Invensys Response to Request for Additional Information (RAI)

Ref: Letter dated December 8, 2010, NRC to Invensys

<u>Attachment</u>	<u>RAI No.</u>	<u>Description</u>
1	1	RXM Safety/Non-safety Interface versus Interim Staff Guidance (ISG)-4
2	2	Assignment of Safety-related and Non-safety I/O to RXM Chassis
3	3	Testing Related to RXM Chassis Failures
4	4	Document Listing for FPGA Development
5	5	Response Time Compliance with EPRI 107330
6	6	Determinism and Use of Interrupts

Main Processor

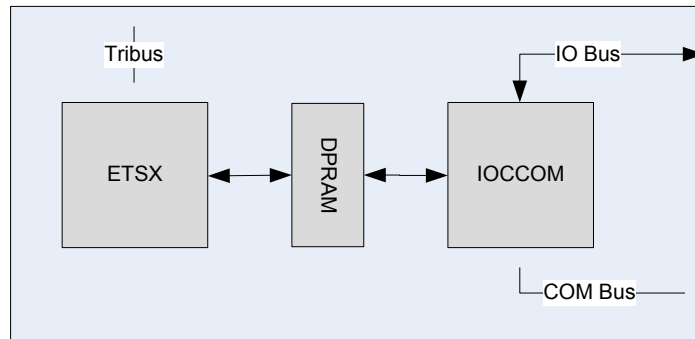
In Section 2.1.3.3 of the Triconex Topical Report Revision 3, Invensys document 7286-545-1, Invensys states that the TriStation 1131 function subset does not allow constructs that could lead to non-deterministic timing. However, there is no mention of the deterministic behavior of the Tricon design itself. Please provide a description of the deterministic behavior of the Tricon platform, including interrupt handling.

The 3008N Main Processor module consists of three main subsystems as shown in the figure below:

Each subsystem consists of a microprocessor and memory subsystem. The ETSX (Enhanced Triconex System Executive) is responsible for running the user defined application program on the Application Processor. The IOCCOM Processor is responsible for communications with the I/O modules in the system and the Tricon communications modules (TCM). The DPRAM provides the interface between the ETSX and IOCCOM. The DPRAM is divided into several sections:
